Predator V56 Release Notes

DocRev: A
Date: 2014-03-12

New Feature: Surface Interval on Main Screen

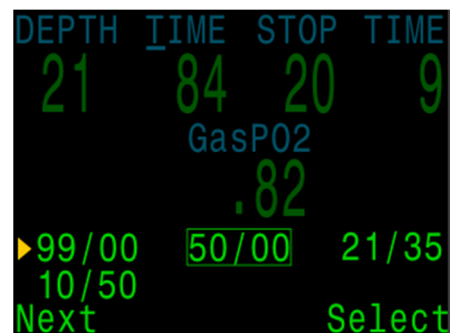
The main screen now shows the surface interval since the end of the last dive in the place of the deco STOP TIME display.

This time is cleared when the tissues are cleared (e.g. after a battery change).

New Feature: Gauge Mode

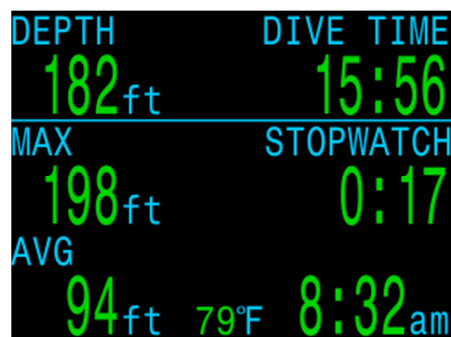
A gauge mode is now available in the “System Menu->Dive Setup->Mode” menu.

When switching to or from gauge mode, the deco tissues are reset (since gauge mode does not tracking which gas is being used).

Gauge mode features a stopwatch and has a resettable average depth function.

New Feature: Configurable Center Row

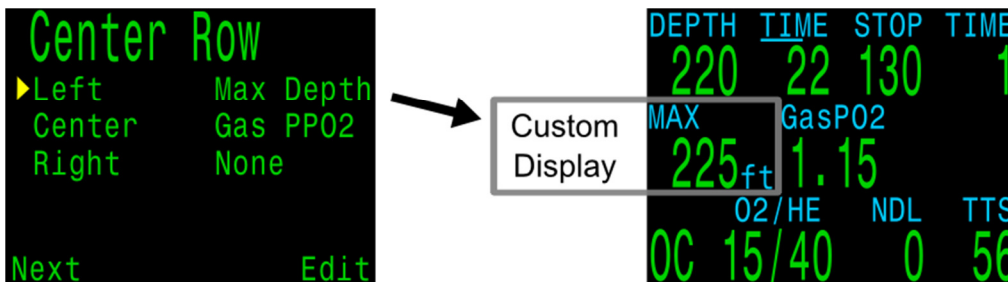
The center row can be configured if space is available. Unfortunately, when PPO2 from 3 external O2 sensors is being displayed, there is no space for configurable displays.

Configure the Center Row in the "System Setup->Center Row" menu.

The center position can only display PPO2. In OC only mode, the PPO2 display can optionally be turned off.
